# UNITED STATES PATENT AND TRADEMARK OFFICE

APPLICATION NO.	FILING DATE	FIRST NAMED INVENTOR	ATTORNEY DOCKET NO.	CONFIRMATION NO.
10/559,533	12/02/2005	Tadashi Okiyama	057788-0318680	9144

<b>Office Action Summary</b>	<b>Application No.</b> 10/559,533	<b>Applicant(s)</b> OKIYAMA, TADASHI	
	<b>Examiner</b> SHEFALI D. PATEL	<b>Art Unit</b> 3767

## **DETAILED ACTION**

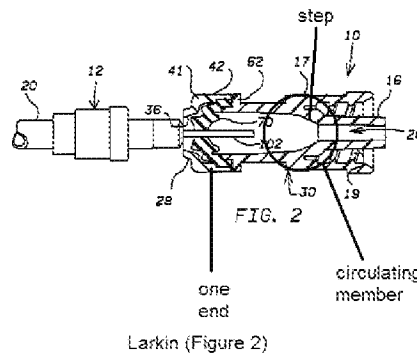
In regards to claims 1 and 15, Larkin teaches a mixture injection port (Figures 1-3) comprising:

- a. a channel tube unit (connector [10])
- b. a septum (seal [70]) covering one end of the channel tube unit [10] and having a slit (slit [74]) into which a tube member (cannula assembly [12]) is inserted
- c. a circulating member (*labeled in Figure 2 below*) provided in the channel tube unit [10] below the septum [70]

Larkin does not teach that the circulating member comprises a plate portion and an edge portion. Wiltse teaches a mixture injection port (Figures 1-6, valve [18]) with a circulating member comprising a plate portion (flow metering valve plug [30]) arranged to change the direction of flow of a first fluid injected from an inserted tube member (coupling nipple [16]) or a second fluid flowing from the other end of the channel tube unit (outer valve parts [22][24]) (Figure 4) and an edge portion (end wall [50]) that

Wiltse (Figure 2)

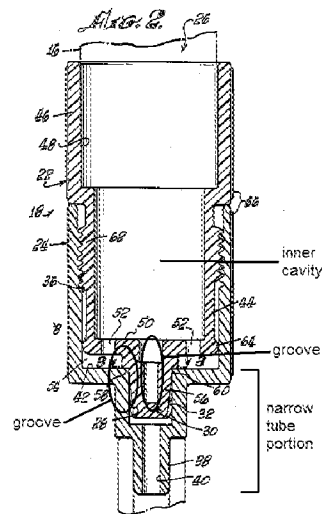
Larkin does not teach a plate portion of the circulating member that is mounted on the step, a groove on the surface of the plate portion, a holding portion on the back face of the plate portion, or a groove on the back face of the plate portion and the holding portion. Wiltse teaches that the plate portion [30] is mounted on a step (wall surface [42])

between an inner cavity (labeled in Figure 2 below) and a narrow tube portion (labeled in Figure 2 below). Wiltse also teaches a groove (labeled in Figure 2 below) formed on a surface on the inner cavity side of the plate portion [30], a holding portion (lower cylindrical portion [56]) on the back face of the plate portion, and a groove (labeled in Figure 2 below) on the back face of the plate portion and the holding portion. It would have been obvious to a person having ordinary skill in the art at the time the invention was made to modify the step, of the modified port of Larkin and Wiltse, by mounting a plate portion upon the step, as taught by Wiltse, as the plate portion will enable the user to regulate and block fluid flow through the injection port based on the fluid needs of the patient (column 2, lines 45-55).

Garrett et al (Figure 3)

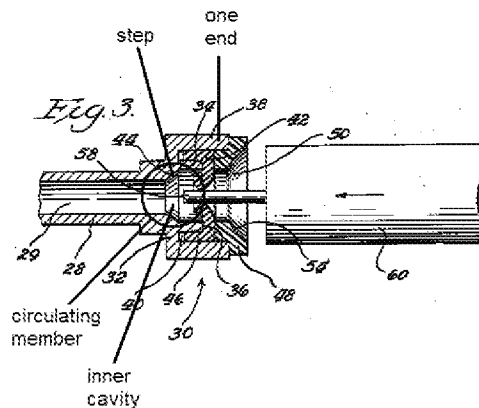
In regards to claims 1 and 15, Garrett et al teaches a mixture injection port (Figures 3-4) comprising:

- a. a channel tube unit (close irrigation site [30])
- b. a septum (membrane [42]) covering one end of the channel tube unit [30] and having a slit (slit [56]) into which a tube member (syringe [60]) is inserted
- c. a circulating member (*labeled in Figure 3 below*) provided in the channel tube unit [30] below the septum [42]

Garrett et al does not teach that the circulating member comprises a plate portion and an edge portion. Wiltse teaches a mixture injection port (Figures 1-6, valve [18]) with a circulating member comprising a plate portion (flow metering valve plug [30]) arranged to change the direction of flow of a first fluid injected from an inserted tube member (coupling nipple [16]) or a second fluid flowing from the other end of the channel tube unit (outer valve parts [22][24]) (Figure 4) and an edge portion (end wall [50]) that protrudes upwardly from a periphery of the plate portion [30] and is arranged along an inner wall of the channel tube unit (Figures 2 and 4). It would have been obvious to a person having ordinary skill in the art at the time the invention was made to provide the circulating member, of the port of Garrett et al, with a plate portion and an edge portion, as taught by Wiltse, as the plate portion with the edge portion will enable the user to regulate and block fluid flow through the injection port based on the fluid needs of the patient (column 2, lines 45-55).

- a. a body portion (base [32]) whose opening (mouth [44]) is covered by the septum [42] and that is provided with an inner cavity (*labeled in Figure 3 above*) for accommodating the septum that is deformed by the insertion of the tube member [60] (Figure 3)
- b. a leg portion that is provided with a narrow tube portion (tubular branch [28]) having a smaller width than that of the inner cavity, wherein the narrow tube portion is configured to provide communication between the inner cavity and the other end of the channel tube [30] (Figures 1-2)
- c. a step (*labeled in Figure 3 above*) formed between the inner cavity and the narrow tube portion [28]
